Office Action Summary	Application No. 10/525,864	Applicant(s) HANLON, MARK	
	Examiner EVAN H. LANGDON	Art Unit 3654

DETAILED ACTION

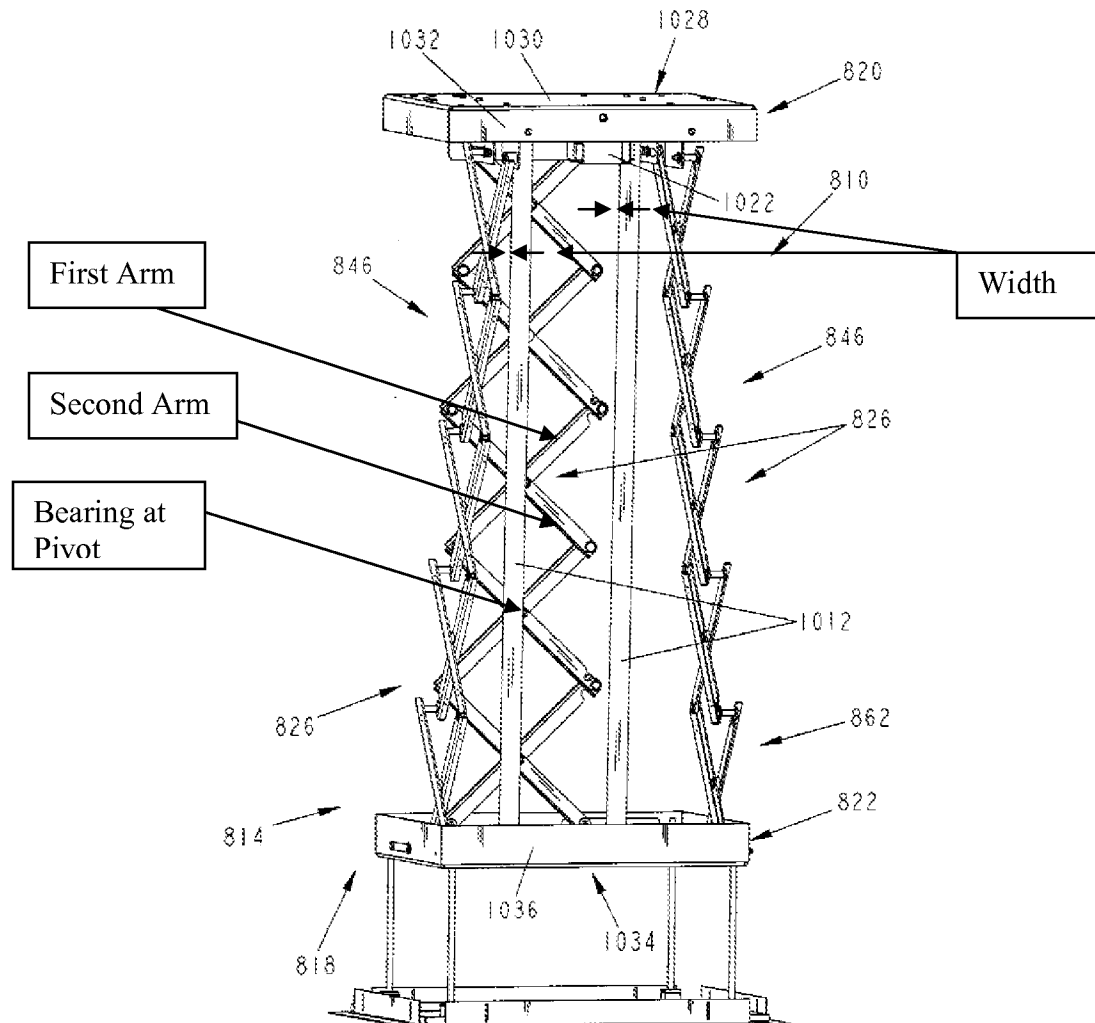
a support frame 1028 housing a double fabric panel drive assembly 824 (Fig. 31) with first and second panels 1012 the panels driven by a drive roller 1014 cooperating to raise and lower a lifting platen 1034; and

a stabilizer 826 having a first arm and a second arm (Fig. 32 and 36, see below), such stabilizer disposed between the support frame 1028 and the lifting platen 1034, and disposed relative to the panels to prohibit motion in all but one plane.
